Permit Type Permit Number Opened Date
Building/Residential/Misc/Pavilion B23003991 10/02/2023
Description of Work
sfd/ Construct 18x18 pavilion. 4 6x6 corner posts, 12" overhangs all sides. Cathedral open ceiling with exposed collar-ties.

From: Williams, Jeffrey
Sent: Friday, December 1, 2023 3:34 PM
To: nick@hometownlandscape.com
Cc: Eshenbaugh, Melanie
Subject: 6505 Heather Glen Way pavilion

Re: Pavilion Build, Permit# B23003991

18418 PAVILION PERMIT # B23003991

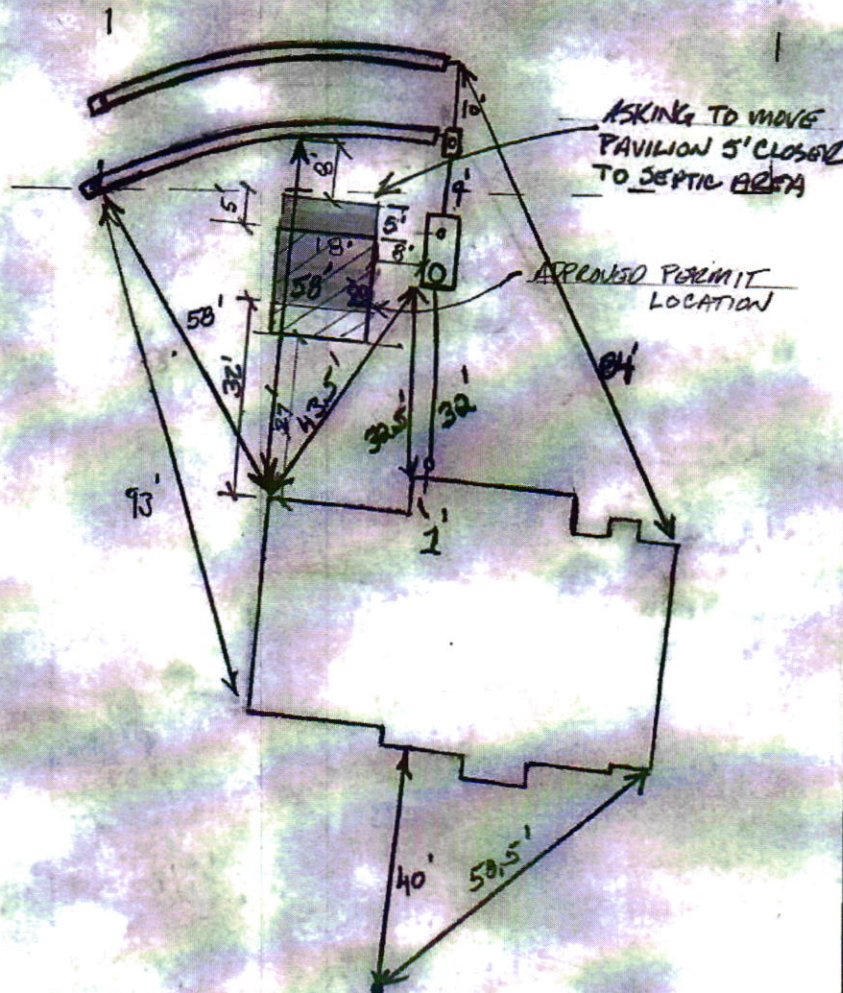
Considering the above, we are formally requesting a variance to allow us to move the pavilion closer to the edge of the septic easement, deviating from the required 5' setback. The attached septic layout plan provides a detailed depiction of all impacted components, allowing you to visualize the proposed changes more effectively.

As you review our case, we kindly ask for your consideration not only of the requested 5' variance but also the possibility of permitting the pavilion to move even closer to the "trench line." Every foot gained in this adjustment is a significant improvement for us and would contribute greatly to the overall functionality of the pavilion.

The owner is now asking if we can move the pavilion 5' further toward the septic easement (down the hill to avoid grade issues on the upper end).

I took good measurements to confirm the septic components and marked the new proposed location of the pavilion.

Hello. I reviewed the waiver request to move the proposed pavilion at 6505 Heather Glen Way inside the 5' setback to the sewage disposal area. I have a few questions related to this waiver request:

- The waiver request mentions that the owners would ideally like the pavilion in the spot where the playground was located. I want to clarify what location is being requested and what might be approved with a waiver. Are they asking for the pavilion to be in the location of the playground with this request? Looking at the aerial photos and the septic install as-built drawing, the playground appears to be well inside the sewage disposal area and over the current trench locations. I want to make sure they understand that location is not possible with a waiver and that is not what they are asking for now.

Depending on the answers above, I may be open to a reduced setback to the sewage disposal area. Please note that a request to move the pavilion inside the sewage disposal area is not possible via the waiver process. If they want to pursue that route, they would need to pursue revising the sewage disposal area to carve out the portion requested. If they want to pursue this option, I can give a better answer of what distance from the trenches I am open to once I get an answer to the questions above. Please also note that any revision to the disposal area to get the pavilion closer to the trenches would also require them to have a contractor accurately field locate the closest trench in its entirety before any waiver review or approval. Thanks
